**MODEM TESTING AND ADAPTATION DATA CHANGES  
TO SUPPORT THE FAA WARP PROGRAM; ITWS  
PROGRAM; AFWA OPUP PROJECT; AND  
STANDARDIZING PORT NAMING CONVENTION**

**DOPPLER METEOROLOGICAL RADAR  
WSR-88D**

**Data Code: 3118758**  
**Issuance Number: EHB 6-00-02**  
**Issuance Date: 22 March 2000**  
**NWS Rescission Date: 1 April 2001**

**NWS: EHB-6, Modification Note 59**  
**DoD: TO 31P1-4-108-587**  
**FAA: EEM Modification Handbook 6345.1 CHG 19, Chap 16**

Figure 1. Detail Cross Connect Diagram

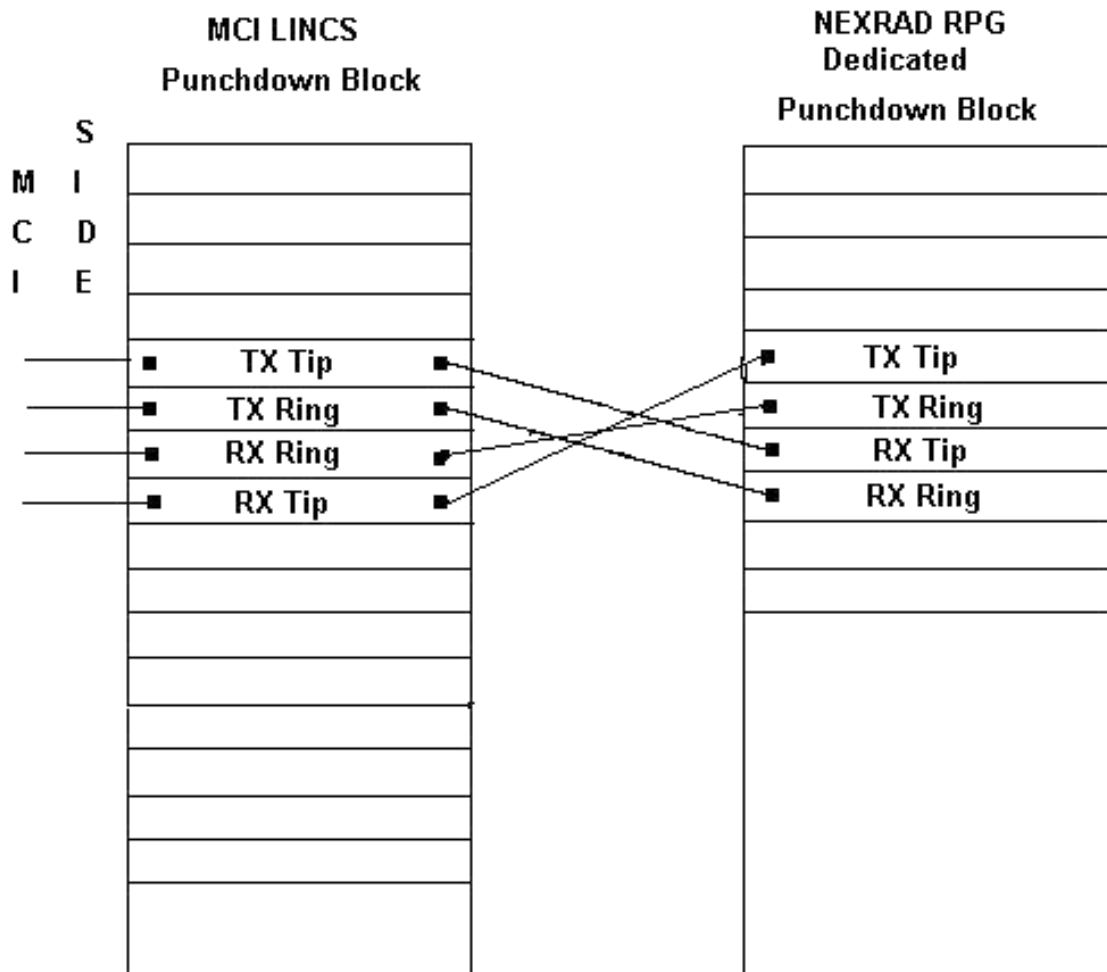
- k. Install 4 wire Telco cable WC63-5BB4U between the MCI 66 block and the appropriate RPG 66 block location(s). Refer to [ATTACHMENT 3](#) for Site-Specific Narrowband Circuit Reports and [ATTACHMENT 4, Figure 1](#), for detailed cross connect diagrams. Not all sites will be connected to WARP, ITWS, and/or OPUP.
